Scandex (Bd) Ltd (Extension)

1 December 2025

1. Building Information

1. Store Building: 3-storied (G+2) RC building.

Observation-03: Lack of information in design report (Store Building).

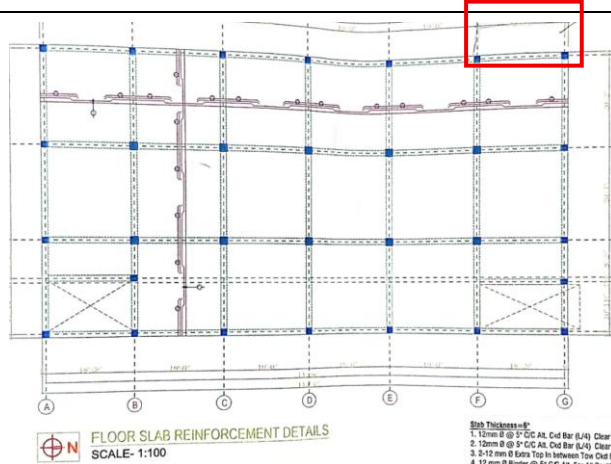
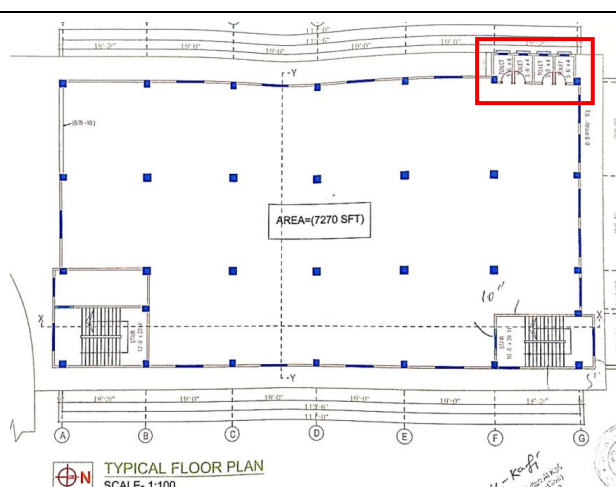
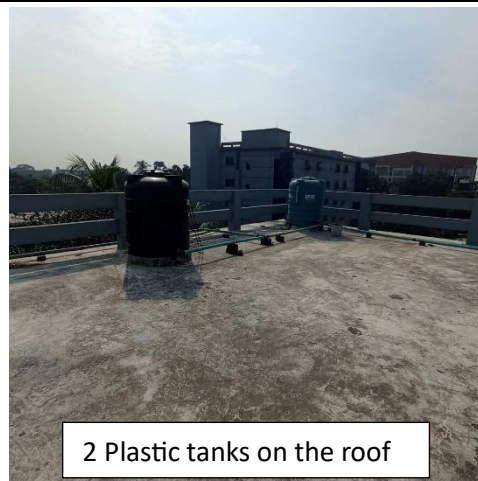
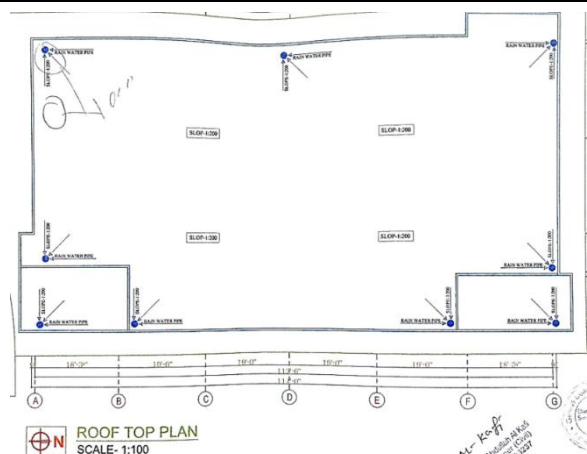
Description: A design report was available, which doesn't include the punching/flexural capacity check of the foundation, serviceability and irregularity check of the building as per BNBC. The building engineer is required to update the design report as per 1.9.1 BNBC and submit it to RSC for detailed review.

4.	Lack of information in the design report (Store Building).	The building engineer is required to update the design report as per 1.9.1 BNBC and submit it to RSC for review.	within 6 weeks
